- PRODUCT(S):** **SFP:** PIXMA iP3000/iP4000/iP5000/iP6000D/iP8500
 MFP: PIXMA MP750/MP760/MP780
- AFFECTED:** All Units
- DESCRIPTION:** ##359 (for MFP) / 13 Alternating Blinks (for SFP) Paper Feed Position Error
- SOLUTION(S):** Realign the Lift Cam Shaft Assembly

FIGURE 1 : LIFT CAM SHAFT ASSEMBLY

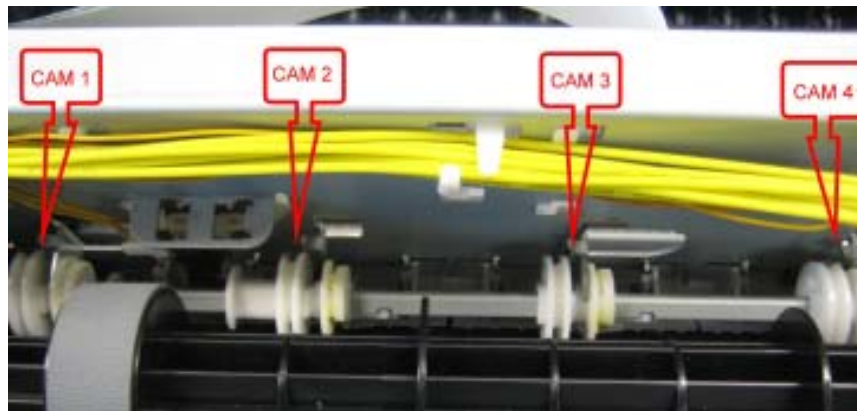
Sudden movement or impact (i.e. from shipping) may cause the Lift Cam Shaft Assembly to shift. When this occurs, the Cam Shaft slides inside the bracket to the right, which prevents the Cam Shaft from rotating properly. This will cause a ##359 (for MFP) / 13 Alternating Blinks (for SFP) Paper Feed Position Error.

INCORRECT POSITION FOR THE LIFT CAM SHAFT ASS'Y

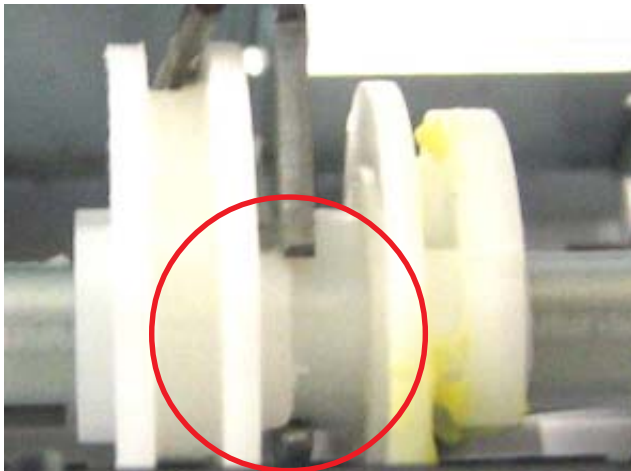
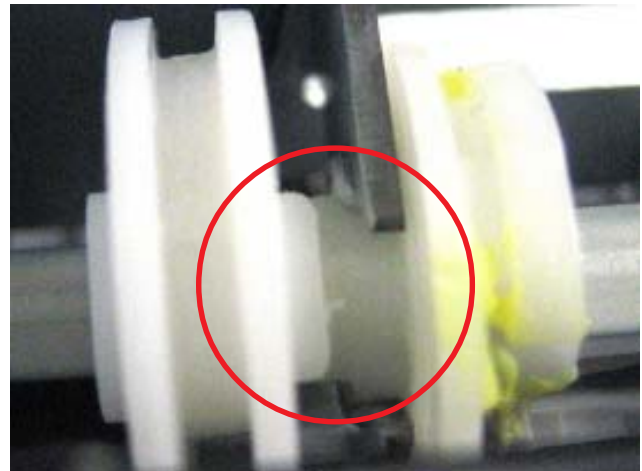
- Turn the machine off and remove the power cord.
- MFP:** Remove external covers, Scanner Unit & Middle Frame.
SFP: Remove external covers & Main Case Unit.
- Check all connections on the Logic Board.
- Check the Lift Cam Shaft Assembly position & the position of Cam 3 (see Figure 1 above).
